# Urgent Field Safety Notice

## SBN-CPS-2020-014

## 9180 Electrolyte Analyzer - wrong arrow direction for Calcium results on system display

<b>Product Name</b>	9180 Electrolyte Analyzer
<b>System</b>	9180 Electrolyte Analyzer
<b>GMMI / Part No</b>	9180 Electrolyte Analyzer / 03157334001
<b>Device Identifier</b>	
<b>Production Identifier (Product name/Product code)</b>	03157334001
<b>SW Version</b>	All versions
<b>Type of Action</b>	Field Safety Corrective Action

Figure 1

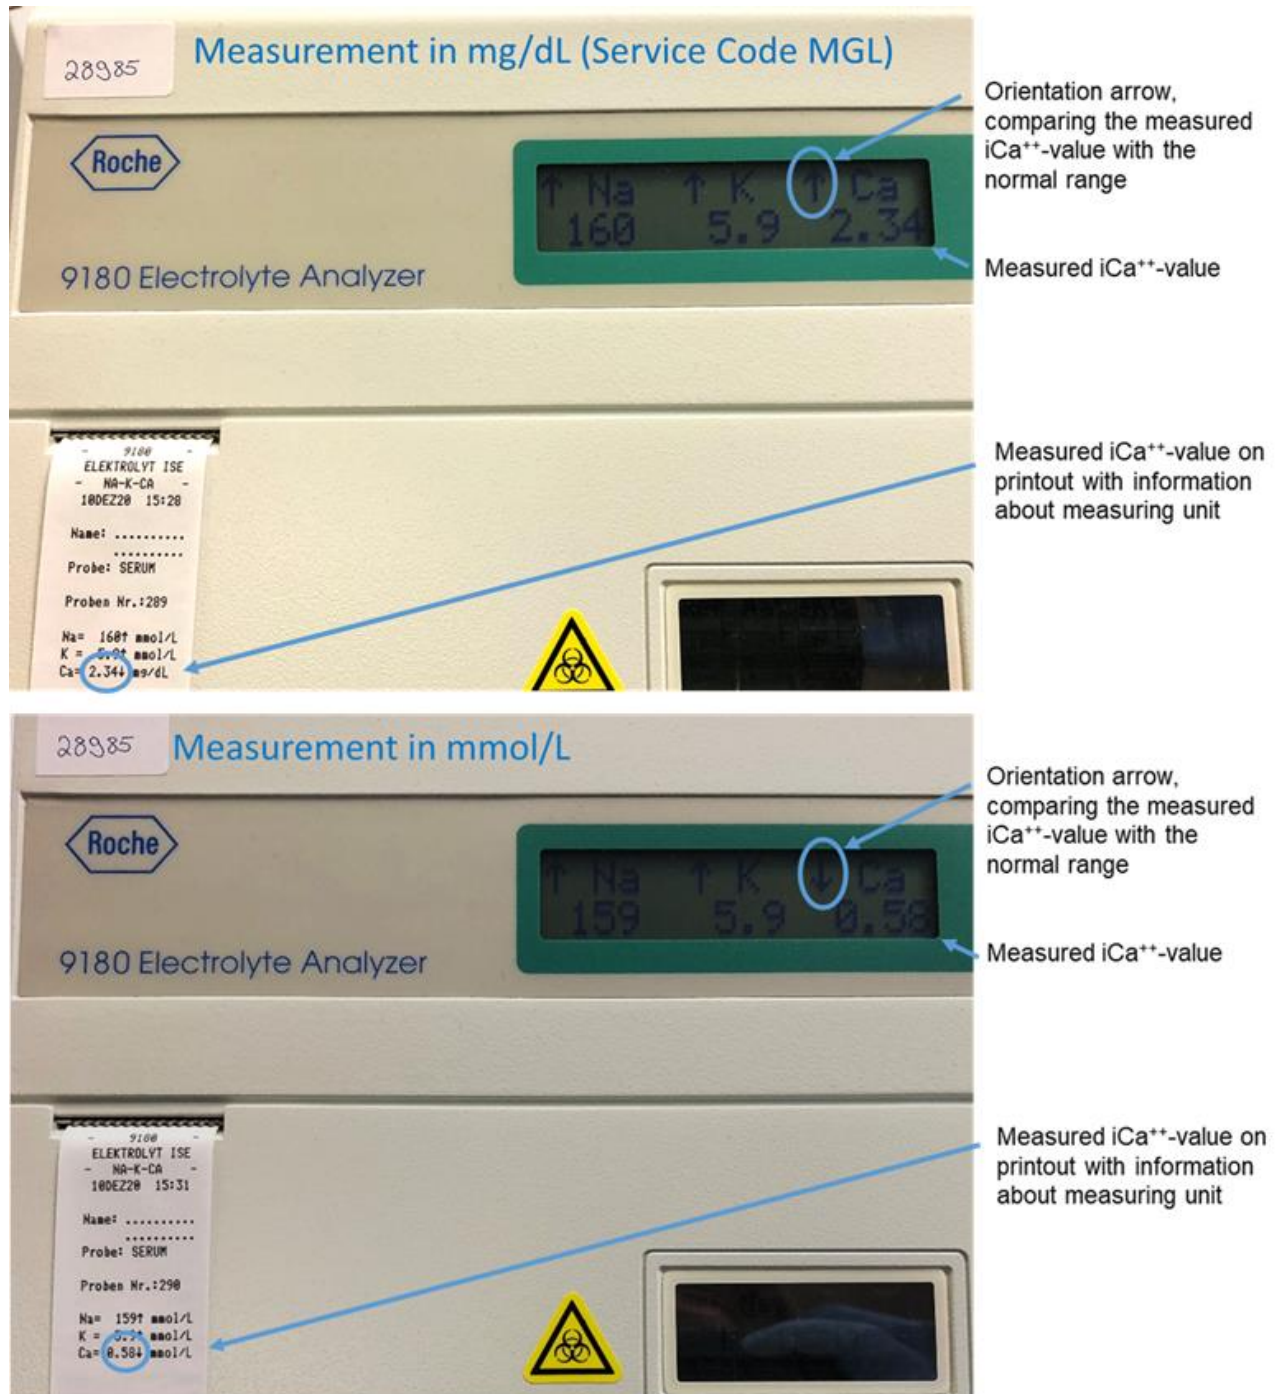
During internal verification studies the following possible scenario was observed: if the unit for iCa<sup>++</sup> is set to mg/dL (Service Code MGL configured) and a measured iCa<sup>++</sup>-value is lower than the normal range, an upward arrow is shown on the display instead of a downward arrow independent of serial number or software version.

The displayed numeric result is correct and on the printout result and arrow direction are shown correctly.

Only iCa<sup>++</sup> is affected.

Make sure that iCa<sup>++</sup> values are reported in mmol/L instead of mg/dL or contact your Roche Services representative. The guiding arrow on the display can be wrong if the unit for iCa<sup>++</sup> is set to mg/dL (Service Code MGL configured) and if a measured iCa<sup>++</sup>-value is lower than the normal range.

If you use the unit mg/dl for iCa<sup>++</sup>, always use arrow information from the printout and not from the display.

Customers are advised to always make sure that iCa<sup>++</sup> values are reported in mmol/L instead of mg/dL or contact the responsible Roche contact person.

It is recommended to always use the printout as the printout shows the correct arrows and units.
